To All Lamborghini Dealers and Licensed Service Point
From Customer Service Department
Subject New bushings and supports for the front torsion bar
Group 147.4.01.00
Date 17.11.2005
Pages 3

New bushings and supports for the front torsion bar.

Murciélago coupe MY 02-03-04.

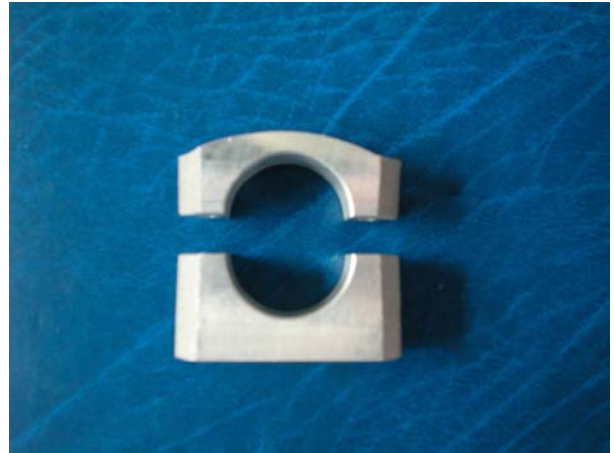
Old parts:

Old bushing for torsion bar p/n 400511324

Old support for torsion bar p/n 400411031A

New parts:

New bushing for torsion bar p/n 400511324C

New support for torsion bar p/n 400411031D

Important remark: In case of first replacement of old parts with the new ones, due to the different technical specifications of the new bushings and supports, it's mandatory to replace the complete kit (2 bushes + 2 supports) on the involved bar, even if only one of the old part is defective, because the new parts are not compatible with the old ones.
